Work Order ID 152887

DESIGN <i>[Signature]</i>	DRAWN BY <i>[Signature]</i>	DART AEROSPACE LTD HAWKESBURY, ONTARIO, CANADA	
CHECKED <i>[Signature]</i>	APPROVED <i>[Signature]</i>	DRAWING NO. D3303	REV. B SHEET 1 OF 4
DATE 06.08.17		TITLE HEAD REST	SCALE 1:3
REV A	DATE 04.08.18	DESCRIPTION NEW ISSUE	
B	06.08.17	UPDATED FLAT PATTERN TO FORM PART IN ONE OPERATION USING OFFSET DIE

DRAWING NO. D3303	TITLE HEAD REST	REV. B	DART AEROSPACE LTD ENGINEERING ORDER		D.E.O. NO. D3303-B-1	SHEET NO. SHEET 1 OF 1	SCALE NTS
DRAWN AJS	CHECKED <i>h</i>	MFG. APPR. <i>h</i>	APPROVED <i>WJ</i>		DE APPR. <i>h</i>		
DATE 08.10.15	DATE <i>08.10.15</i>	DATE <i>08/10/16</i>	DATE <i>08/10/16</i>		DATE <i>08/10/16</i>

D3303-041 HEAD REST

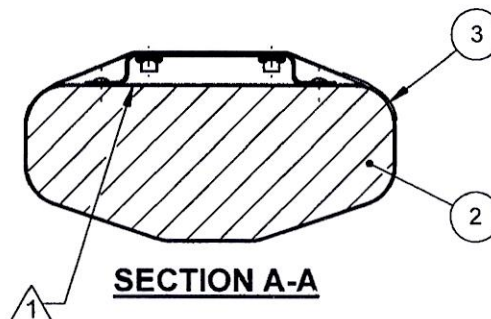
SHEET 1 ADD 1300L ADHESIVE BY 3M TO NOTE 1 AS FOLLOWS:

- 1) BOND D3305-1 FOAM TO D3303-043 BRACKET ASSEMBLY USING 3M 1300 ADHESIVE (0.002" TO 0.010" THICK) IN ACCORDANCE WITH MANUFACTURER'S INSTRUCTIONS

- 1) BOND D3305-1 FOAM TO D3303-043 BRACKET ASSEMBLY USING 3M 1300 OR 1300L ADHESIVE (0.002" TO 0.010" THICK) IN ACCORDANCE WITH MANUFACTURER'S INSTRUCTIONS
